Corrigendum  
For  
Tender for  
Digital X-ray (Flat Panel Radiography Unit with Two Flat  
Panel Detectors) for the Department of Radiology

NIT Issue Date	:	20 <sup>th</sup> July, 2019
NIT No.	:	Admn/Tender/31/2020-AIIMS.JDH
Pre-Bid Meeting	:	30 <sup>th</sup> July, 2020 at 03:30 PM
Earlier Last Date of Submission	:	15 <sup>th</sup> September, 2020 at 03:00 PM
Extended Last Date of Submission	:	29 <sup>th</sup> September, 2020 at 03:00 PM
Bid opening	:	30 <sup>th</sup> September, 2020 at 3:15 PM

**The following revised and additional conditions will be added:-**

**17. Page No 12, Point 13. Installation and Turnkey:**

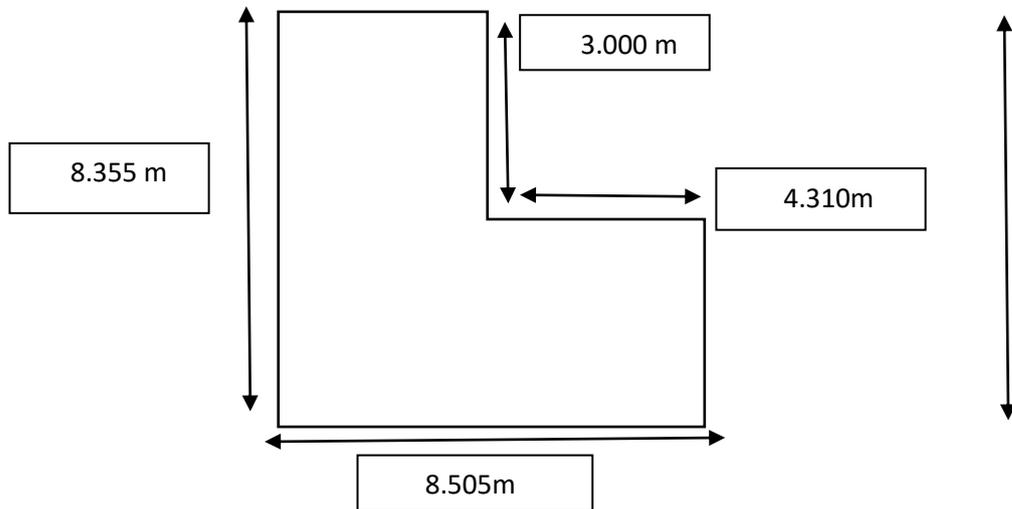
<b>13. Installation and Turnkey</b>
· All site approval, layout approval and registration of equipment from AERB shall be done by Radiology Department AIIMS Jodhpur under assistance of supplier.
· All turnkey work proposed by the selected firm will require approval of HOD of department of Radiology, AIIMS Jodhpur and competent authorities including engineering section, of the institute before implementation.
A complete site preparation plan will be required to be submitted as a turnkey project. The vendor will be eligible to inspect the proposed site.
The cost of alteration and preparation in a specified built in area on turnkey basis which will include civil, electrical and air conditioning and maintenance of air conditioning is to be borne by the firm. Requirement of power and air conditioning must be clearly specified. The room should be adequately air-conditioned and that should be discussed with engineering department of the AIIMS.

<b>Turnkey work:</b> <b>Ceiling work</b> – Metal powder coated false ceiling to be considered. <b>Doors</b> – the doors associated with the examination room to be lead lined laminated wooden doors with hard wood frames, rest all other door would be laminated wooden damage to the wall due to stretchers. Brick wall partition between radiography room and console with lead glass.
Electrical: All general lighting in the area will be carried out by LED light by using copper wiring and PVC conduits. The lights will be of Philips, Syska or equivalent. The switches will be of Crabtree, Havells or equivalent. Earthing for DR system UPS etc to be provided by vendor.
· A state of the art firefighting system with alarm and smoke detectors to be installed and connected to nearest fire panel of hospital. Fire extinguishers 3 nos 2kg ABC type to be provided.

<b>13. Installation and Turnkey</b>
<ul style="list-style-type: none"> <li>• All site approval, layout approval and registration of equipment from AERB shall be done by Radiology Department AIIMS Jodhpur under assistance of supplier.</li> </ul>
<ul style="list-style-type: none"> <li>• All turnkey work proposed by the selected firm will require approval of HOD of department of Radiology, AIIMS Jodhpur and competent authorities including engineering section, of the institute before implementation.</li> </ul>

- A complete site preparation plan will be required to be submitted as a turnkey project. The vendor will be eligible to inspect the proposed site.
- The cost of alteration and preparation in a specified built in area on turnkey basis which will include civil, electrical and air conditioning and maintenance of air conditioning is to be borne by the firm. Requirement of power and air conditioning must be clearly specified. The area should be adequately air-conditioned(15 T of cassette /split AC) and that should be discussed with engineering department of the AIIMS.

**Turnkey work: (Total area is 750 square feet including machine room, console, UPS/battery room and reporting room): please see the drawing as under.**
